VALUE ENGINEERING STUDY

Project # CSSTP-0009-00(396)

Project # CSSTP-0009-00(397)

Atlanta Beltline Southwest and Southeast Corridors Fulton County, Georgia

PROPOSAL NUMBER: B6-2

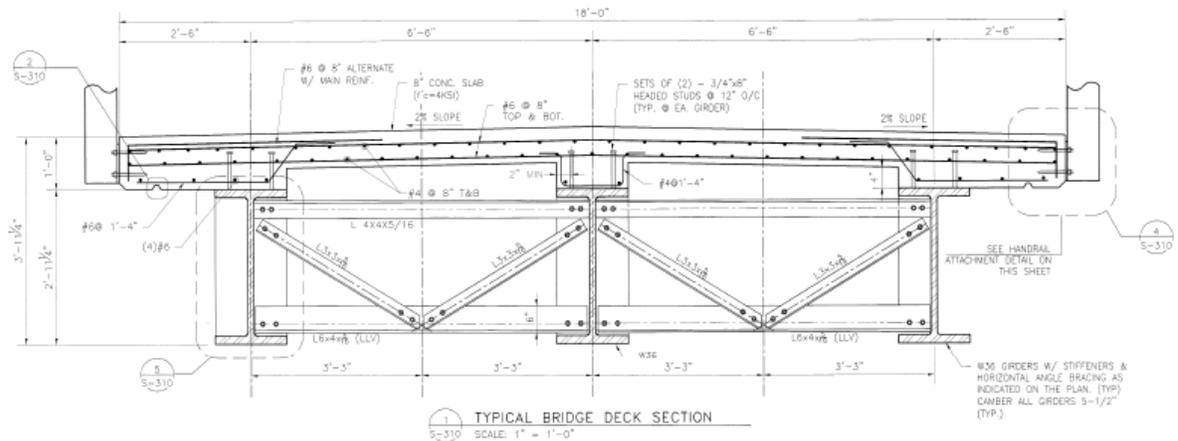
No proposed bridge plans are available but the example bridge provided to the team was the Ralph McGill Bridge. The Ralph McGill Bridge has a superstructure comprised of 3 x 3 ft. deep steel beams with a cast in place (CIP) concrete deck. Based on span to depth ratio's for steel beams, a similar arrangement should be sufficient for this bridge

The proposed design would replace the bridge with a single span prestressed concrete beam bridge.

PROPOSED CHANGE: It is proposed to replace the bridge with a single span prestressed beam bridge.

Granite Clad Retaining Wall
Source: Perkins + Will

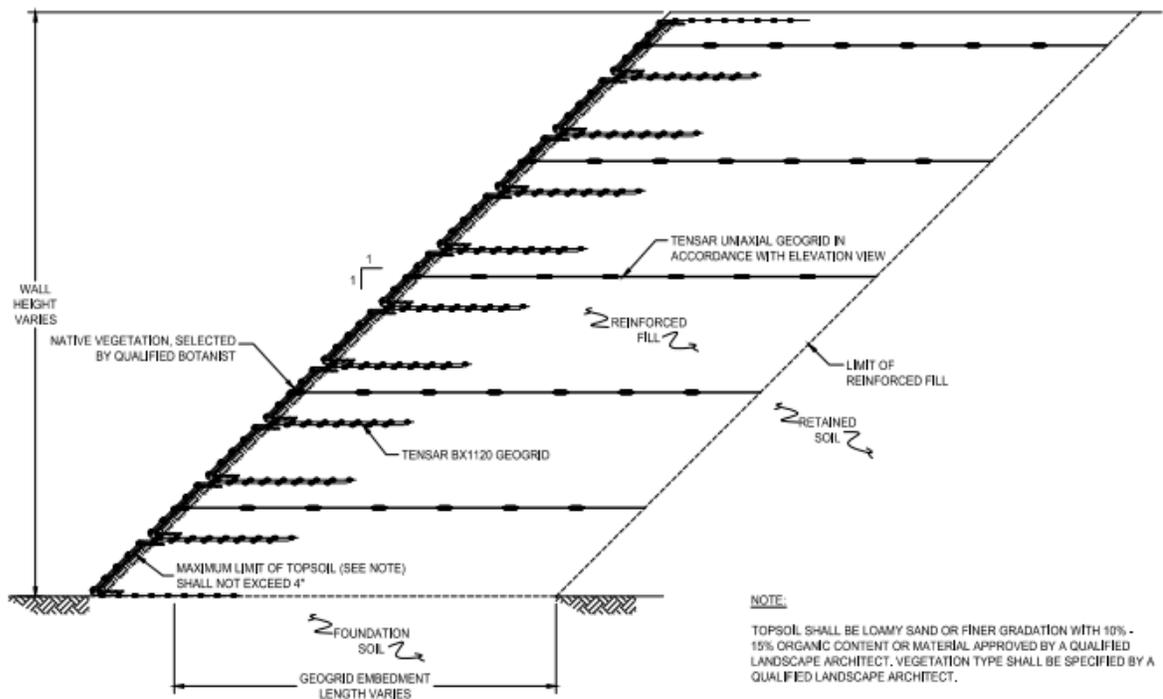
PROPOSED CHANGE: It is proposed to eliminate concrete walls in areas where there is sufficient right of way to use a geo-grid slope at 1:1. The geo-grid walls are only proposed to be used in fill conditions on walls that are under 6 feet in height.

- The 16” Battered retaining wall appears to be adequate for retained fills up to 10 feet.
- Using the 1:1 slope would make the wall “drift” its height in front of the wall if the ground is level.
- Based on the offsets to right of way to provide room in front of the walls to construct Cantilever walls, the “drift” of the geogrid walls should not be an issue for walls less than 10 feet high.
- Assume that 54” fence will be required in lieu of 42” wall mounted fence
- Applied proposed change to fill walls up to 6 feet in height for calculations

Granite Clad Retaining Wall
Source: Perkins + Will

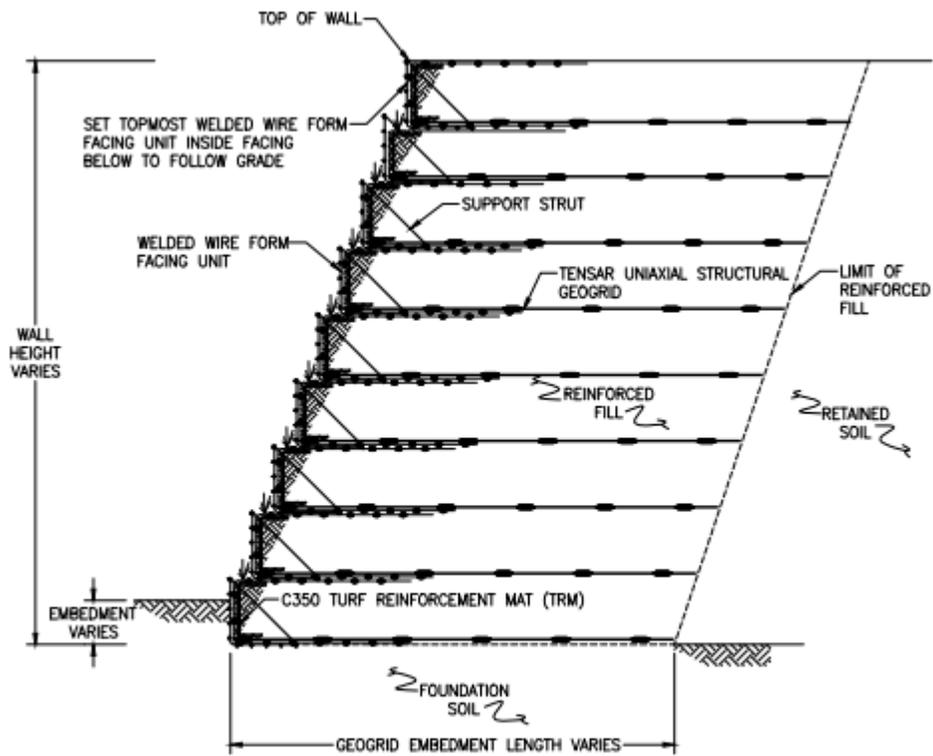
PROPOSED CHANGE: It is proposed to eliminate concrete walls in areas where there is sufficient right of way to use wire basket walls with plant-able facing and 70 degree slopes. Only use them in fill walls with heights under 6 feet.

- The 16” Battered retaining wall appears to be adequate for retained fills up to 6 feet.
- Proposed Change applied to walls with 6 feet in height or less
- Using the steep Vegetated retaining wall face (approximately 70 degrees) the toe of the wall would “drift” forward approximately $6 \text{ ft} / \tan(70) = 2.2$ feet.
- Based on the offsets to right of way to provide room in front of the walls to construct Cantilever walls, the “drift” of the wire-basket walls should not be an issue.
- Assume that fence on top of the wall or slope is approximately the same
- From Janice Reid, Strata Systems, 770-712-1729, \$13/SF of Height for wire basket Geogrid walls.

PROPOSAL NUMBER: B6-3.3

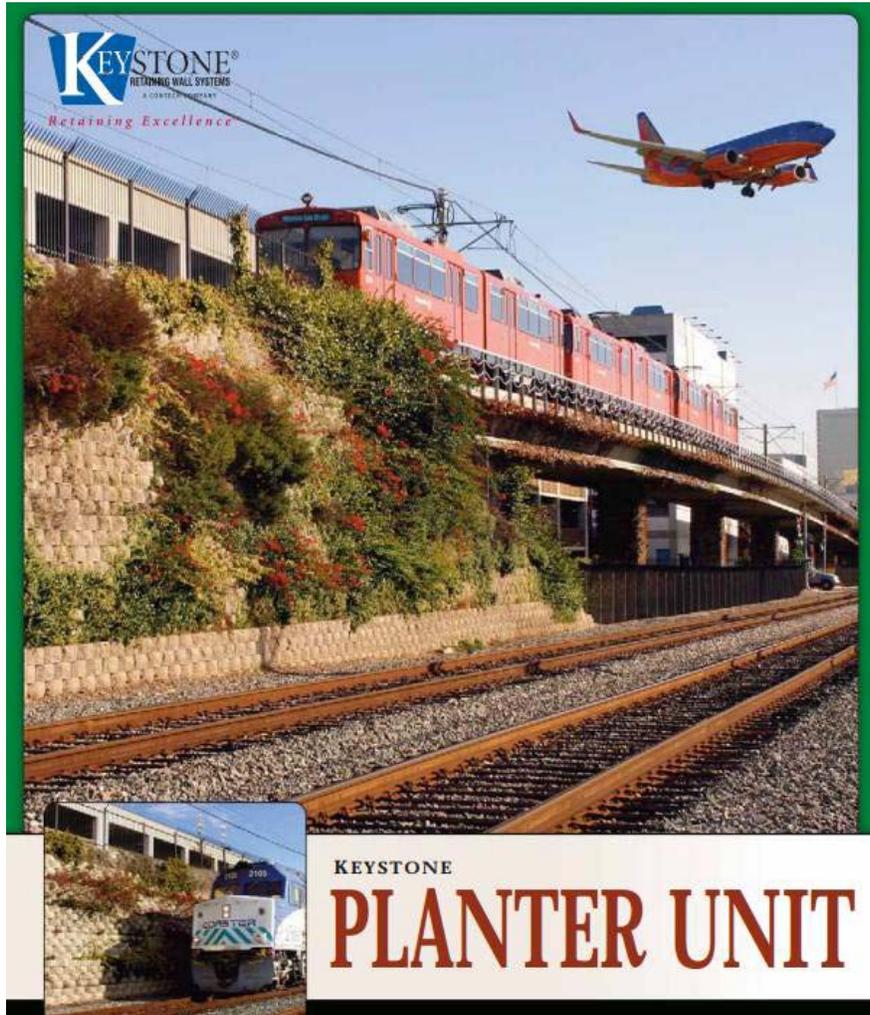
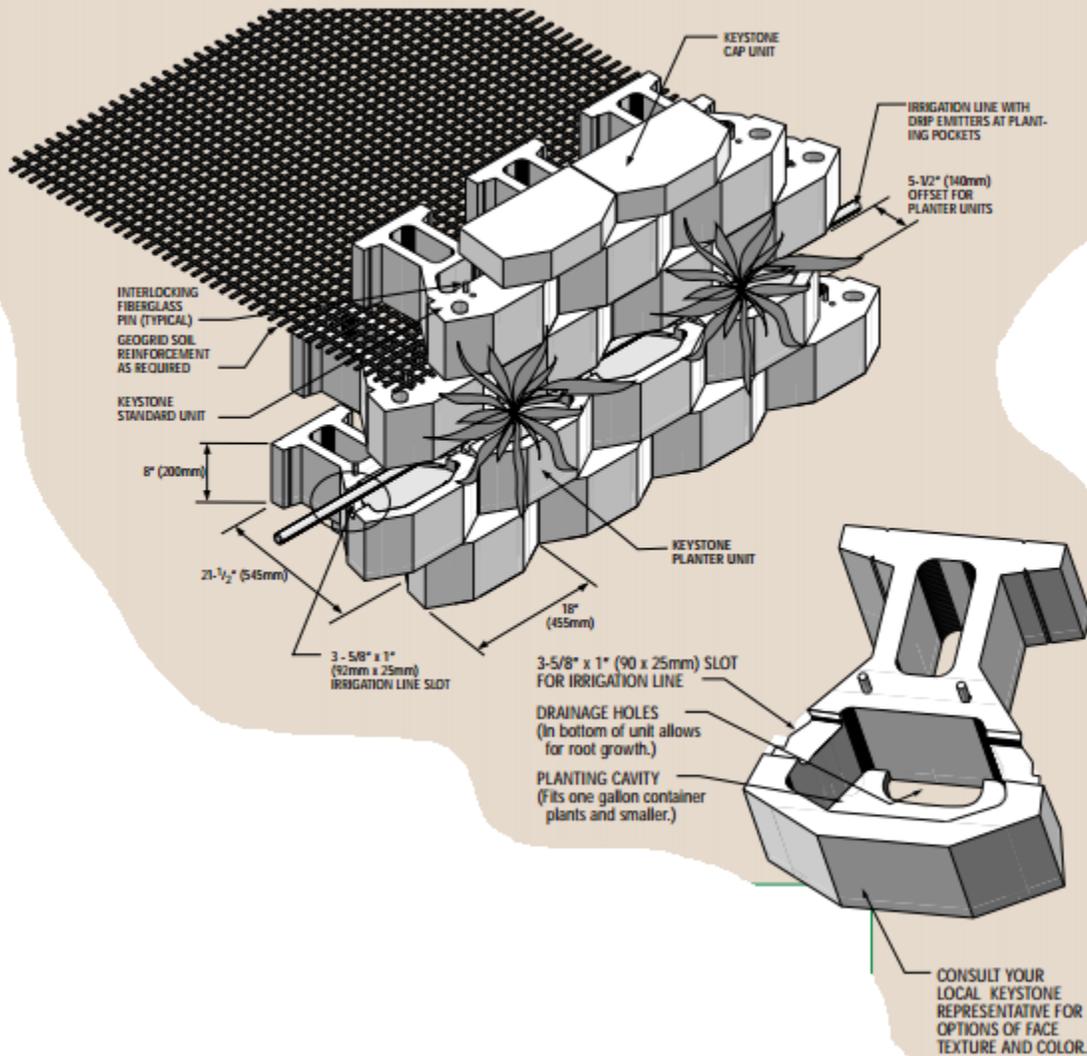
PROPOSED CHANGE: It is proposed to eliminate concrete walls in areas where there is sufficient right of way to use an MSE wall that is able to be vegetated. These are proposed for walls under 6 feet in height.

- The 16” Battered retaining wall appears to be adequate for retained fills up to 6 feet.
- Proposed change applied to walls 6 feet in height or less
- Using the steep Vegetated retaining wall face (approximately 70 degrees) the toe of the wall would “drift” forward approximately $6 \text{ ft} / \tan(70) = 2.2$ feet.
- Based on the offsets to right of way to provide room in front of the walls to construct Cantilever walls, the “drift” of the MSE walls should not be an issue.
- Assume that 54” fence will be required in lieu of 42” wall mounted fence

PROPOSAL NUMBER: B6-4

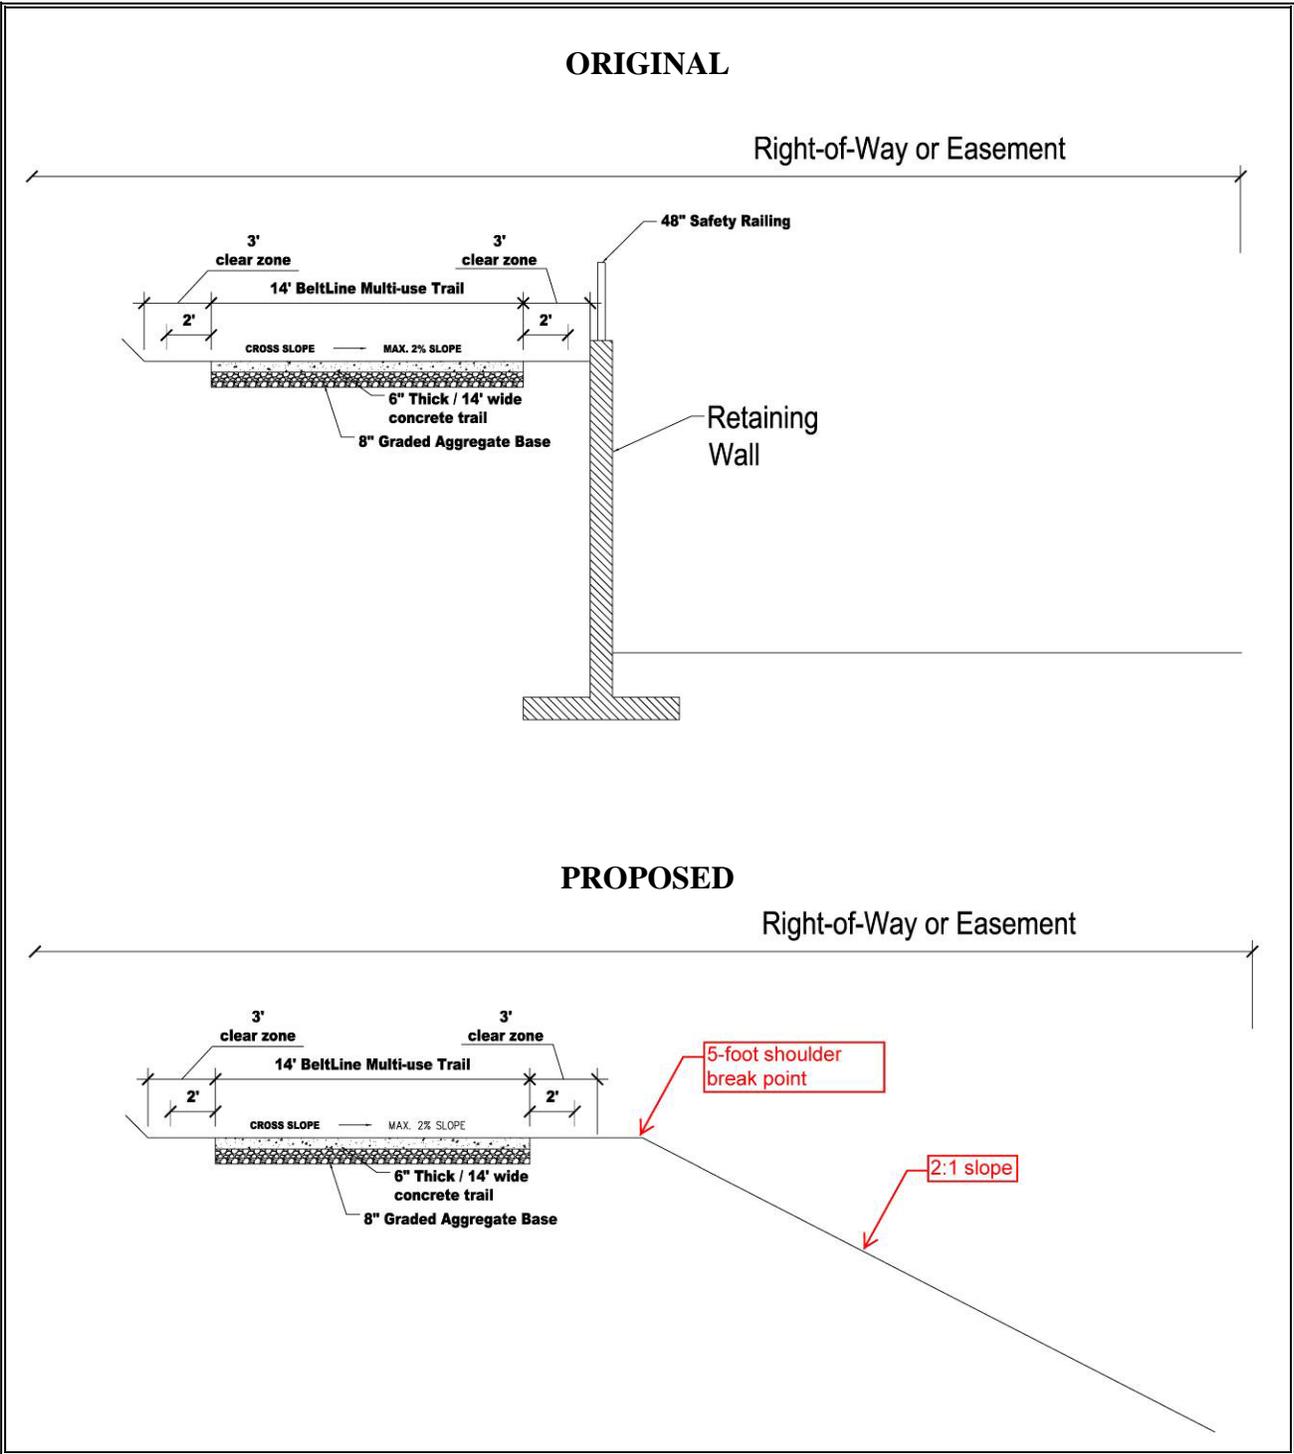
PROPOSED CHANGE: It is proposed to utilize a 5-foot graded shoulder with 2:1 slopes in lieu of retaining walls in locations where wall removal and use of slope will not adversely affect right-of-way or easement limits or adjoining properties. As shown in the calculations sheets within this proposal it is believed that 7 of the 17 retaining walls in the current design can be eliminated or reduced.

To evaluate if 2:1 fill slopes could be used in lieu of retaining walls, it was assumed that the 3-foot graded shoulder would need to be widened to 5-foot minimum to provide adequate recovery distance before the shoulder break to the 2:1 slope. To evaluate if use of 2:1 slope in lieu of a retaining wall was possible, the plan view (25% Plans) was reviewed to determine if adequate space was available to accommodate a 5-foot graded shoulder and a fill slope two times the wall height. If the plan review indicated that adequate right-of-way or proposed easement (as noted in the 25% Plans) was available and that adjoining properties would not be adversely impacted, then the “change” or use of 2:1 slopes in lieu of a retaining wall would be proposed. If adequate width was not available or if additional conditions or constraints were present that would be impacted by the “change”, then the “change” or use of 2:1 slopes in lieu of a retaining wall would not be proposed. Seven of the 17 walls could be changed per this analysis.

PROPOSAL NUMBER: T6-1

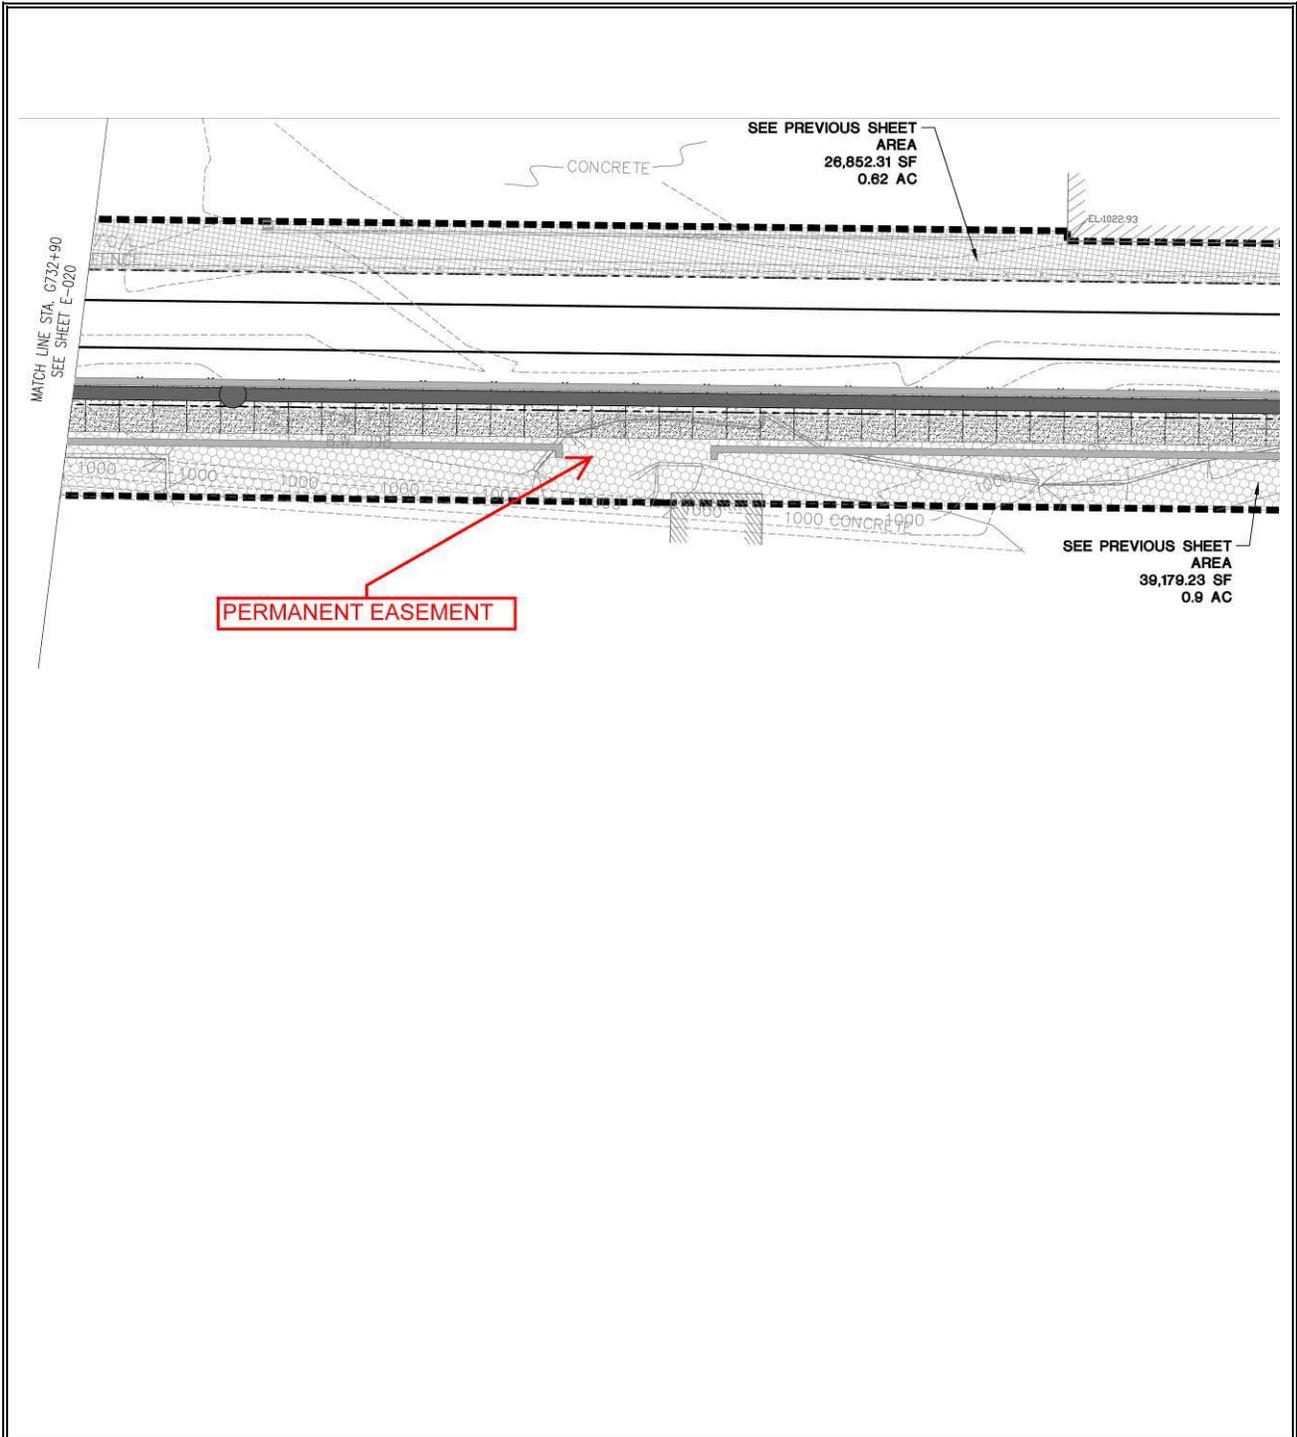
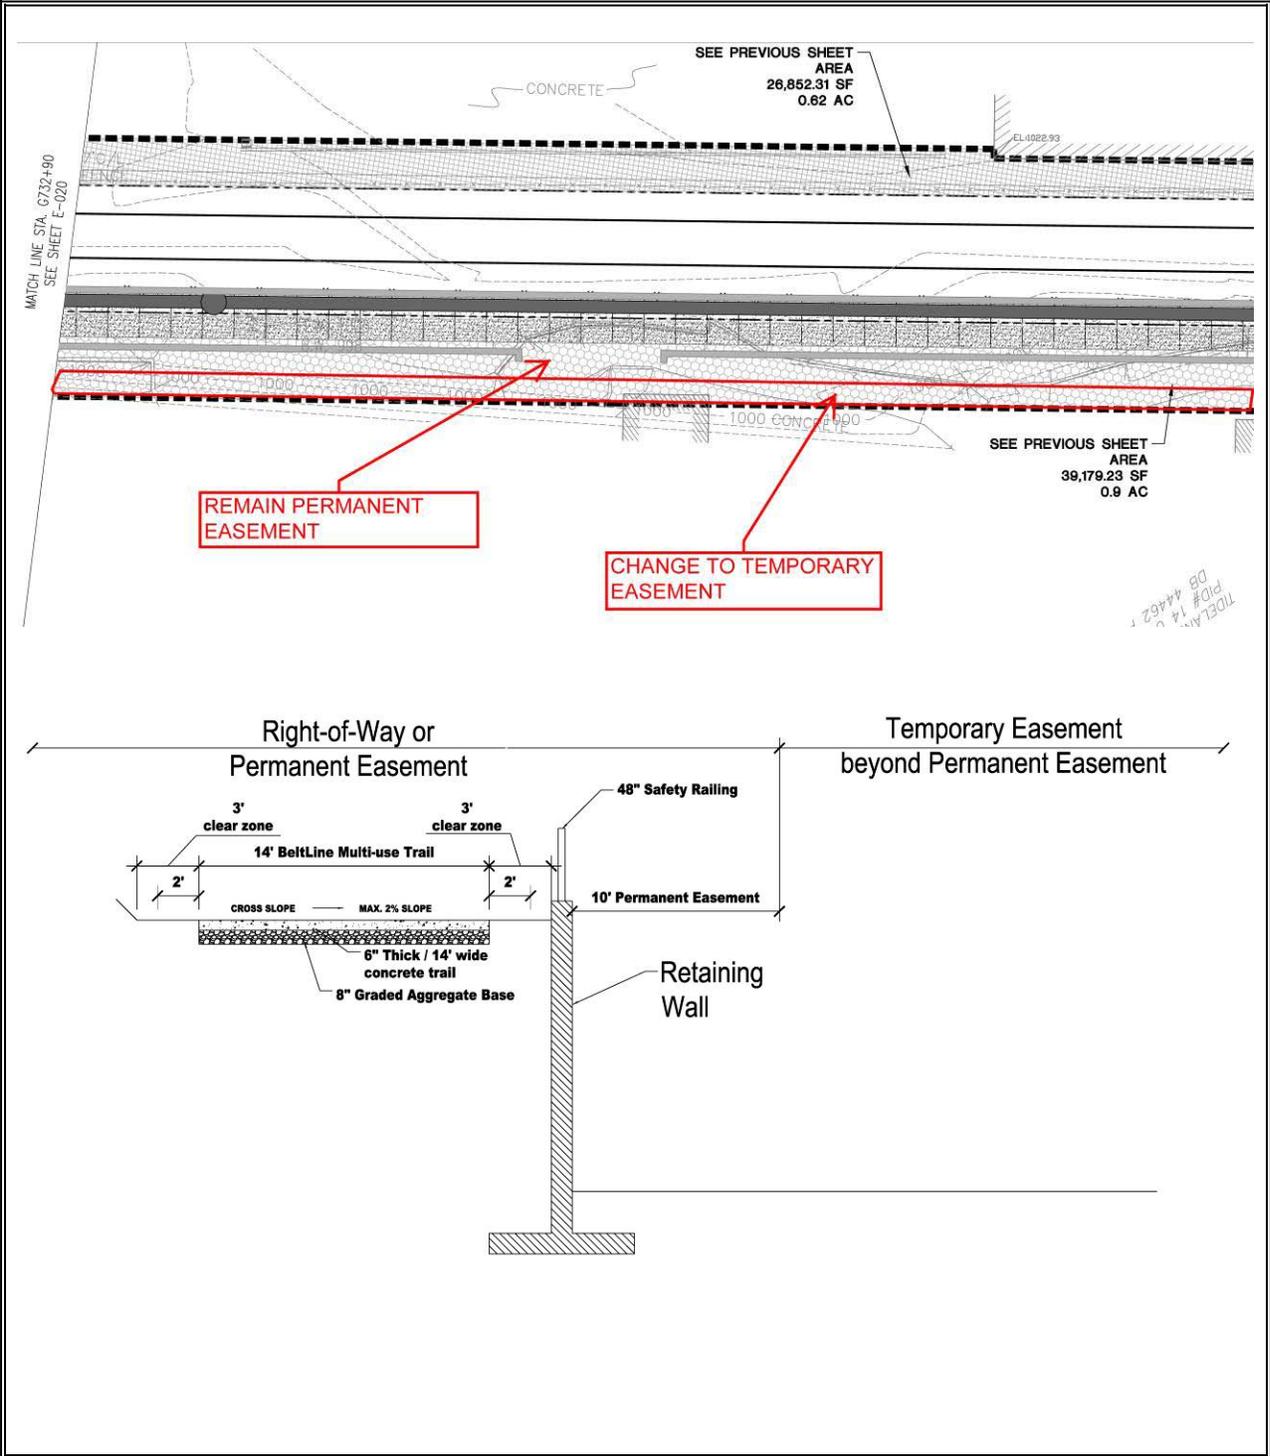
PROPOSED CHANGE: In areas where retaining walls are to be implemented, it is proposed to utilize a permanent easement beyond the face of the walls at a width of 10-feet for fill walls and a width of 1.5 times the height of cut walls. Utilize temporary easements to accommodate the remainder of the limit of work area beyond these permanent easements. As identified in the calculations sheets within this proposal, there are 4 locations where this proposed alternative could be implemented.

1. STA G719+10 (at Ralph David Abernathy Blvd.) to STA G725+30 [Sheet E-018 to E-019]
2. STA G727+00 to STA G728+00 [Sheet E-020]
3. STA G728+80 to STA G745+80 [Sheet E-020 to E-023]
4. STA G747+90 to STA G755+30 [Sheet E-023 to E-025]
